主旨: Re: I-GEN HEALTHCARE CORPORATION, FCC ID: XYUIGEN3, Assessment NO.: AN09T9904, Notice#1

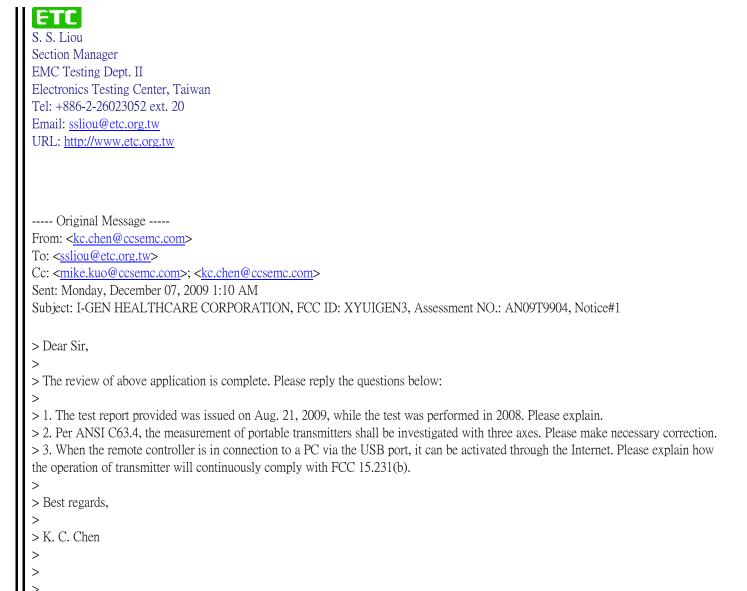
1. The issue date was corrected because the conduction test was completed on Oct. 05, 2009. The radiated emission test was completed in 2008. This project was suspended due to the problem of conducted emission test.

KC: Accepted.
